ARCHITECTURAL REVIEW BOARD REGULAR MEETING AGENDA

Agenda Item: APPLICATION FOR NEW CONSTRUCTION, ARB #25-001, to consider an application for the construction of a new restaurant, Pollo Campero, with a drive-thru, located at 1131 Elden Street, Herndon, Virginia. [Continued from the March 19, 2025, regular meeting pursuant to ARTICLE IV. MEETINGS, paragraph a. of the ARB Bylaws.]

Resolution- to approve ARB #25-001, an application for construction of a new restaurant, Pollo Campero, with a drive-thru, located at 1131 Elden Street. The subject property is further identified as Fairfax County Tax Map 0161 04050009B.

DRAWING TITLE:
REVIEW ELEVATIONS

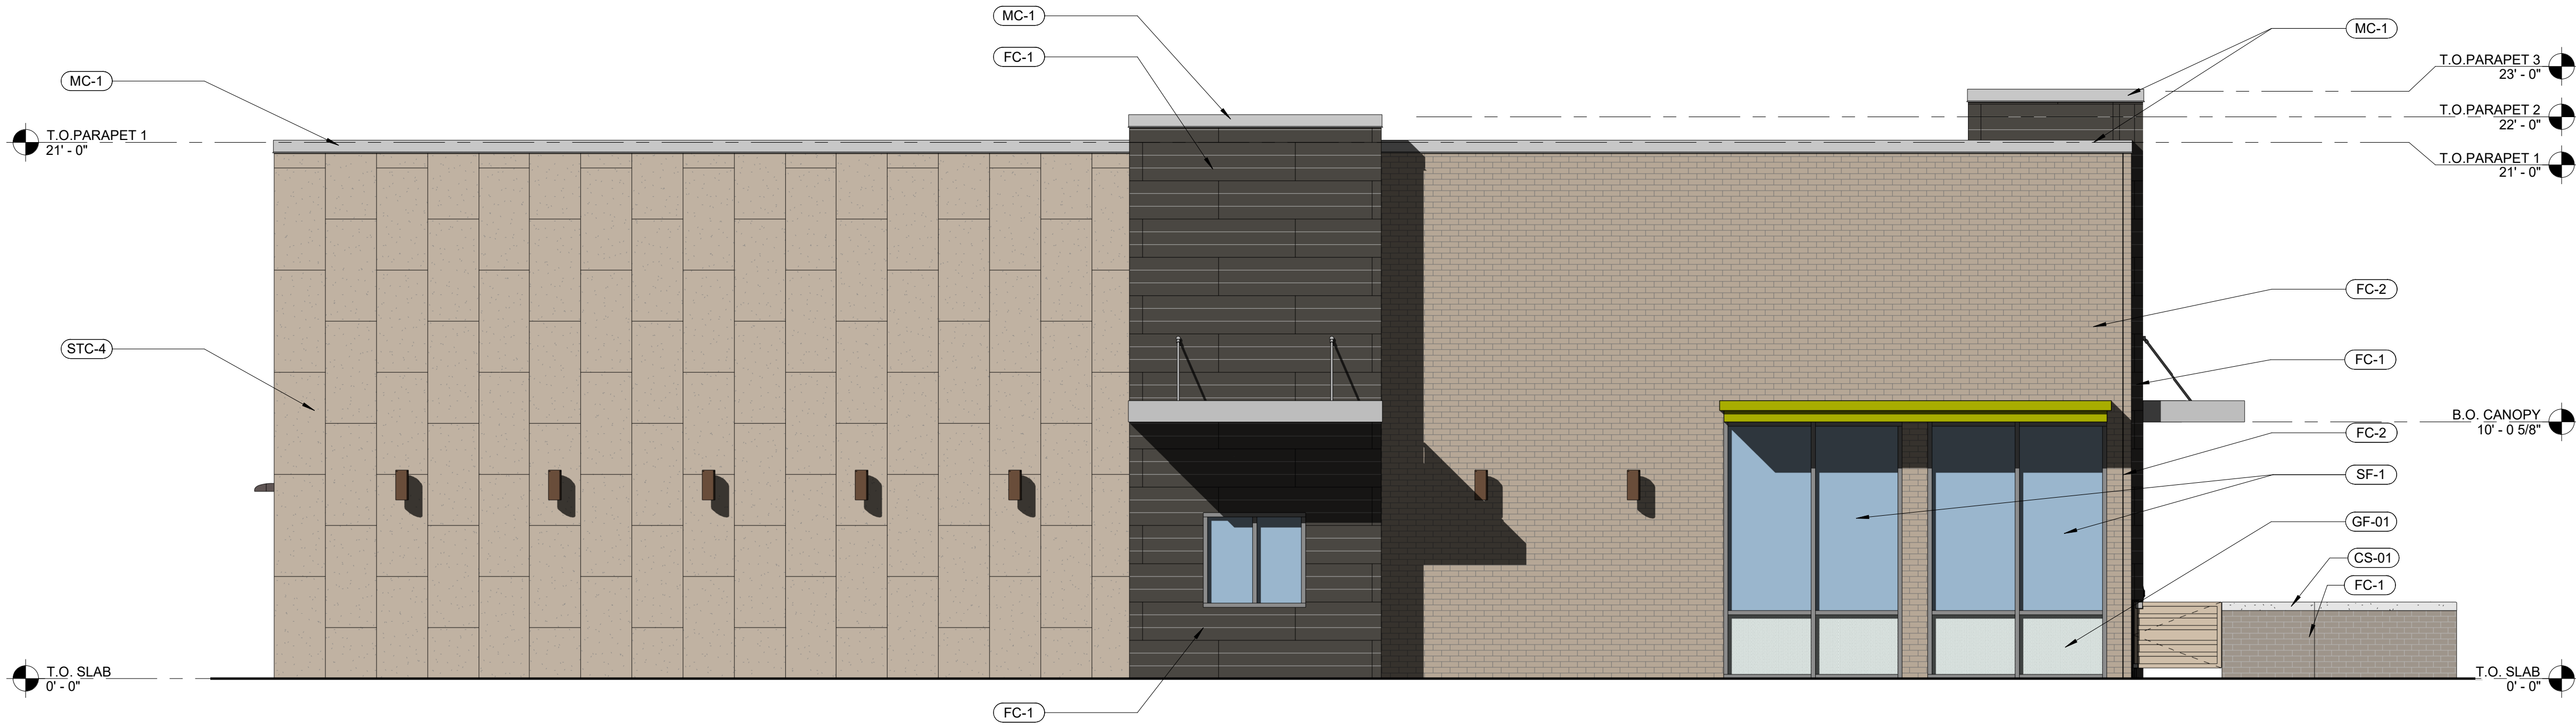
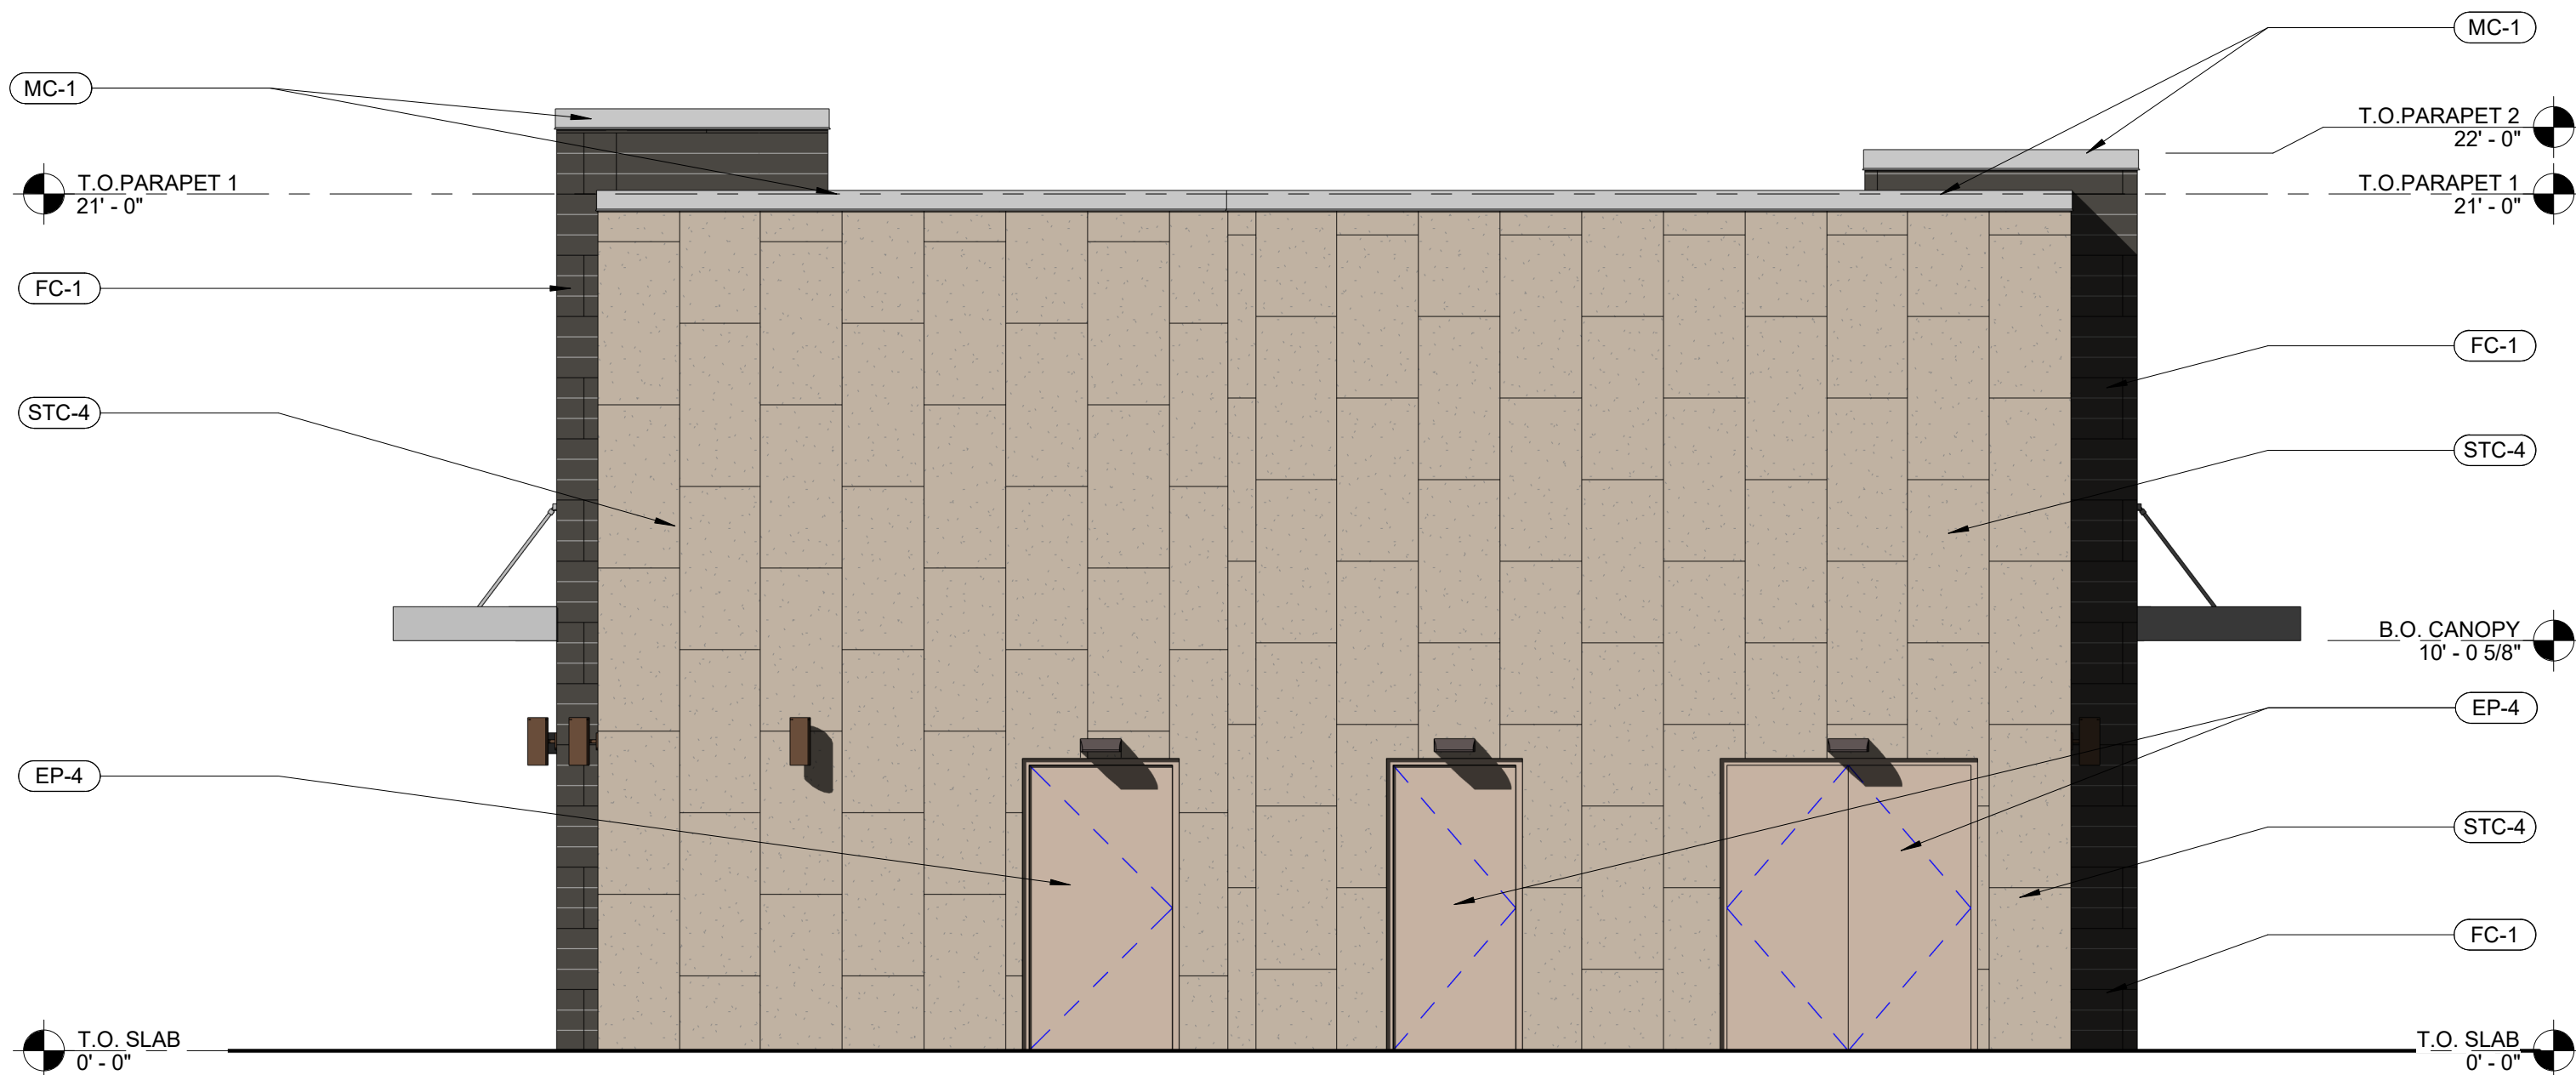
2. Use of the STO Powerwall Synthetic Stucco System. This EIFS product is used exclusively on the back half of the building as the cladding material. Overall, it remains as the most used exterior material. EIFS has been generally discouraged for use as a principal exterior treatments in the Architectural Control District. Issues regarding material and aesthetic durability are often cited. The foam-based system does have known longevity issues and often the finishes and arrangement of panels create an overly flat appearance. The product does offer a range in finishes which can mimic anything from a cement coat to precast concrete and how it is panelized can have significant impact on the texture, scale, and articulation of the wall surface. These details should be fully understood and a good material sample will be important to evaluate.

3. Managing Mass/Scale of Stucco Walls. Regardless of whether it remains EIFS or not, if the back half of the building remains a single cladding material, tactical ways to manage that mass should be explored. Adding a feature such as a few downward sconce lights aligned vertically with the canopy on the side elevations might be a simple way to address the concern.

4. Use of Fibercement Brick Panels. The brick shown in the new design is actually a fibercement faux brick panel. This material has not been approved by the ARB previously and should be carefully considered. It appears to give a fairly good impression of brick with the exception of a straight joint line that is necessary along one side of the outside corner. Clarification should be sought whether the panels can be feathered in at corners to avoid this condition.

- b. The EIFS cladding materials shall be replaced with a fiber-cement panel with a panel size and pattern similar to that shown in the elevation drawings and the applicant shall coordinate with staff for the final review and approval of the revised drawings showing this revision.

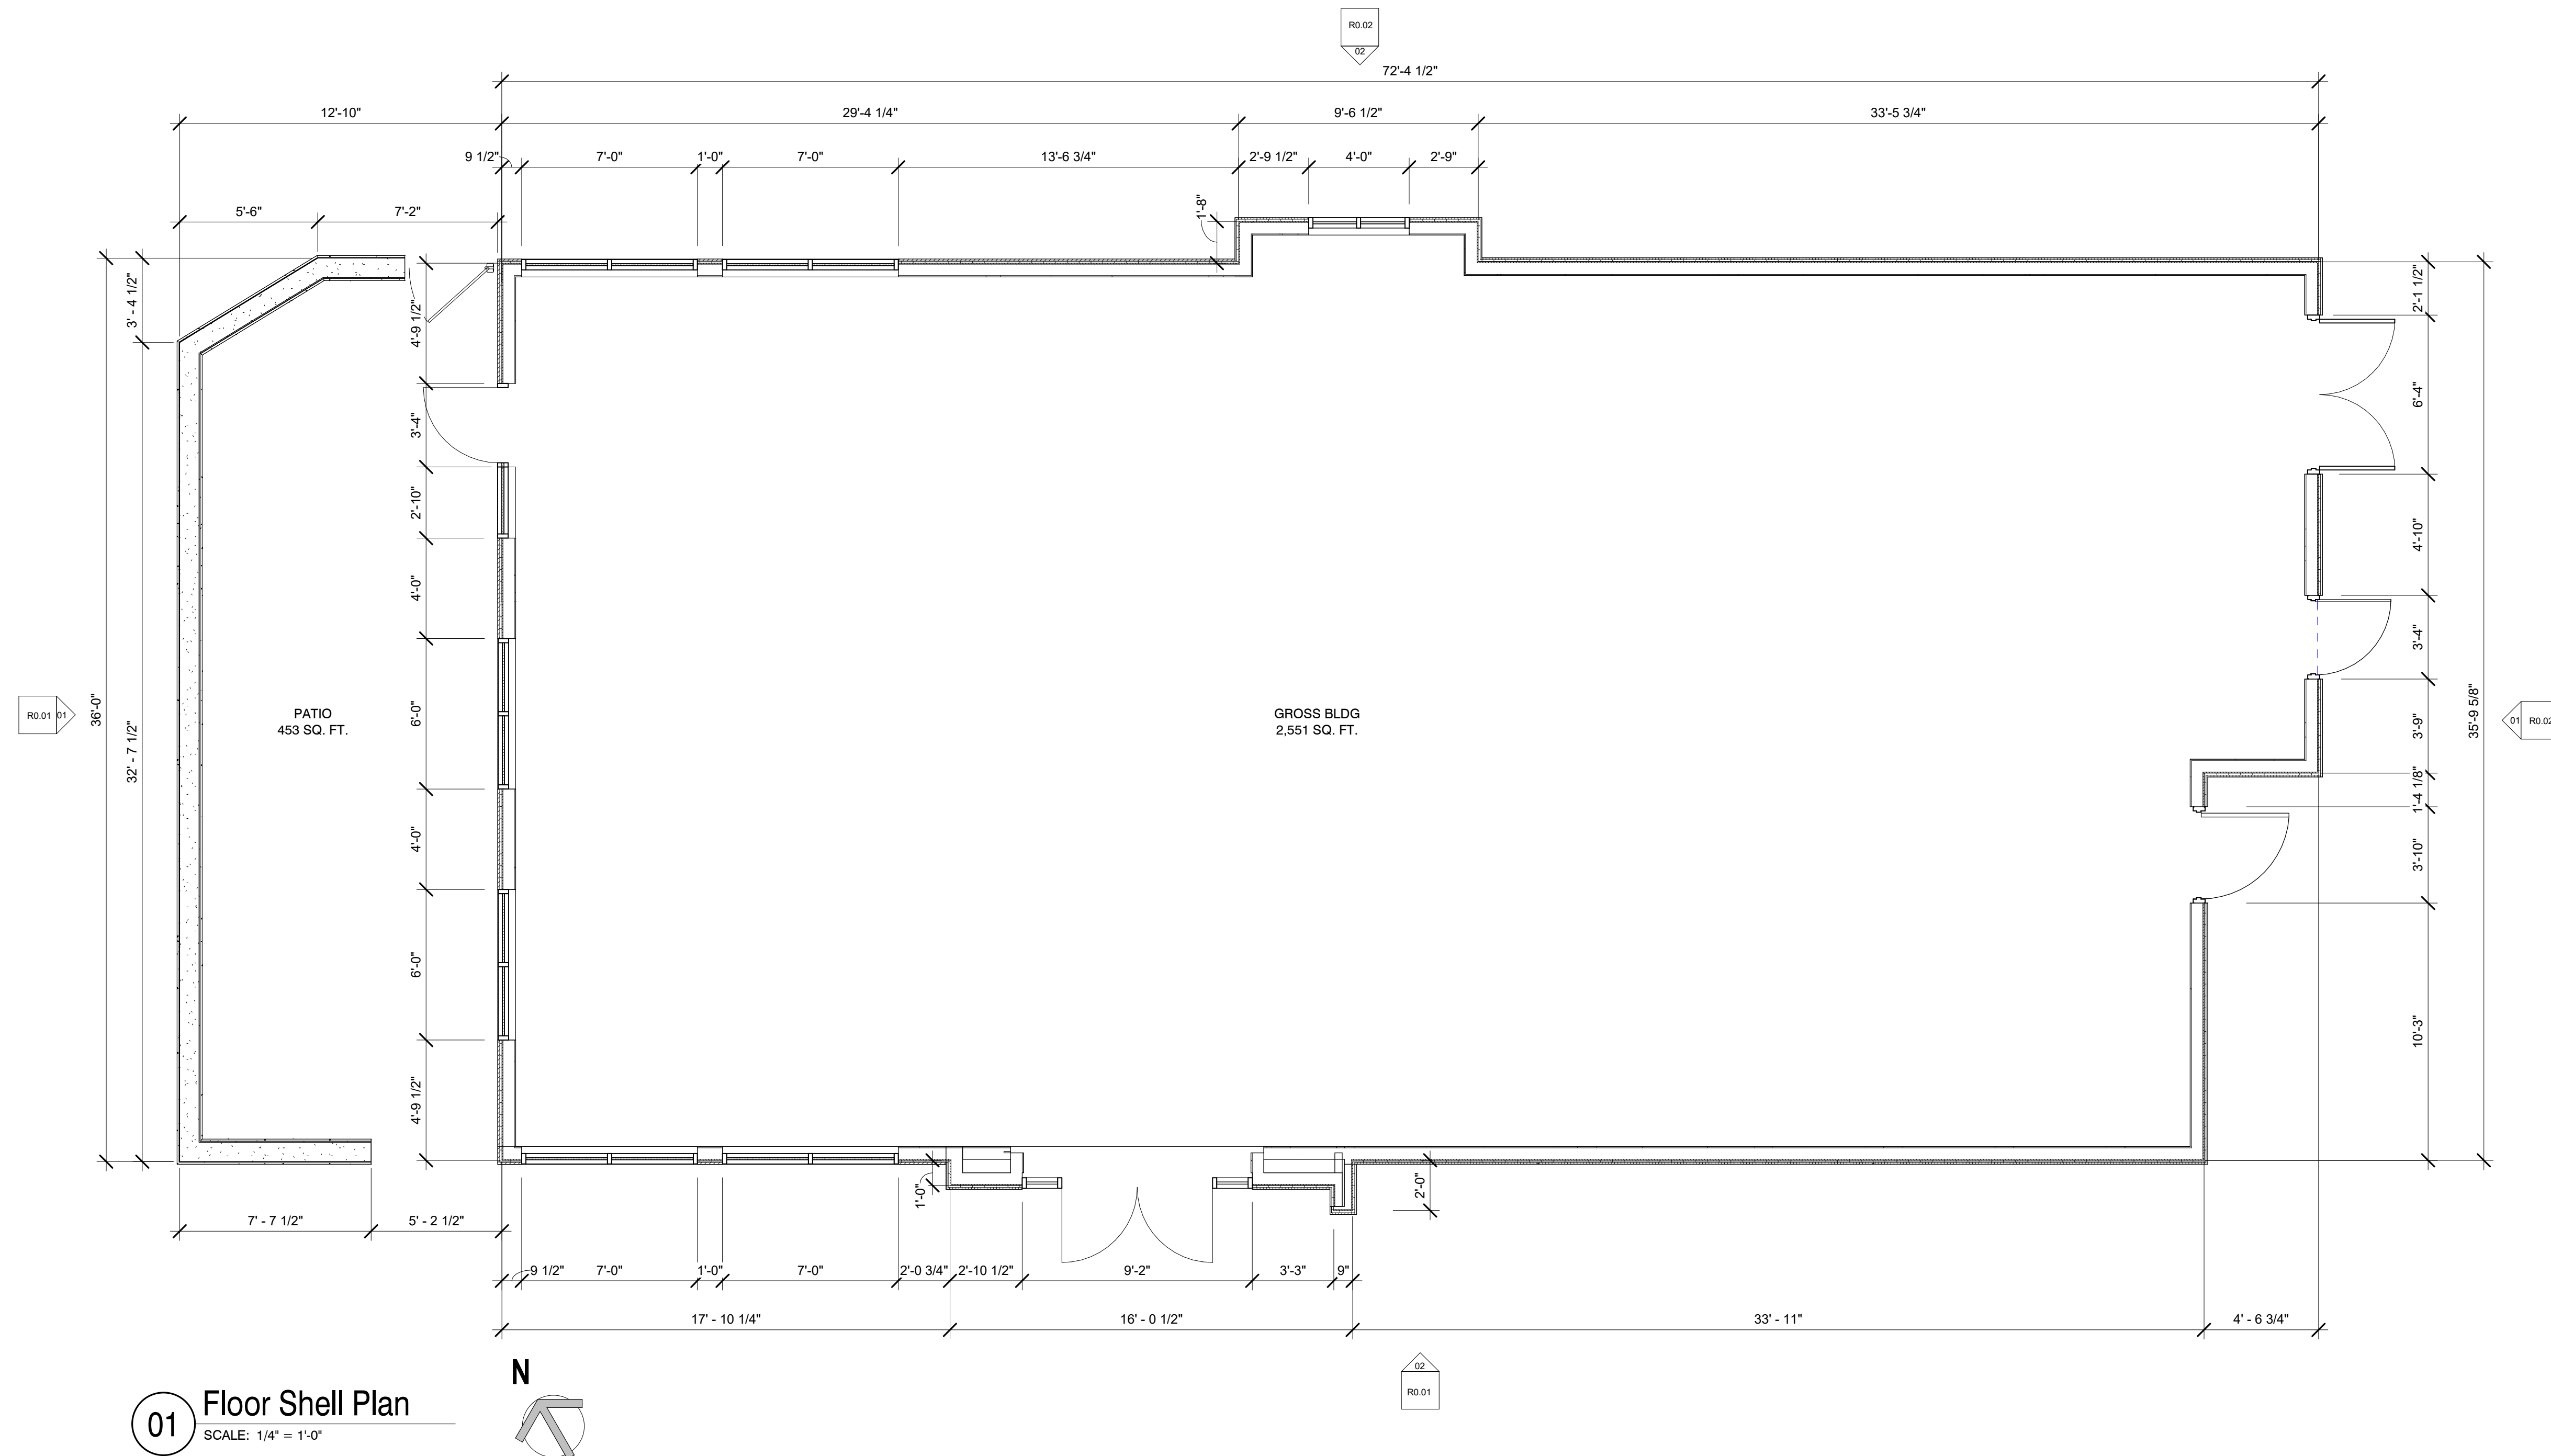
ARB is to ensure a unique Herndon-specific context-based design. Staff sees this as an opportunity for a new design that can meld the business-specific design elements with a refined Herndon character. Staff internally sought to visually express a design approach that addresses the above comments and sketched the following drawings:

- Bringing the storefront down to the ground to maximize visibility into the restaurant for improved street presence and activation.

- Design simplification with better managed colors, materials, and features. Staff suggests doing this by consolidating materials, removing vibrant colors other than when used as an accent, and using only canopies instead of canopies and awnings. It should be remembered that the applicant can use corporate colors, such as the lime green, on the umbrellas and outdoor furniture. In addition, the staff concept still utilizes the corporate architecture's flat panels with the vibrant bands, which will be as shown in the photographs and not in the drawings provided by the applicant or staff.
- Break up the material rhythm vertically, by bring cladding materials to the ground, to better balance the design with the horizontal orientation of the building.
- Use of brick as a primary field color as a more durable and architecturally appropriate material for Herndon.
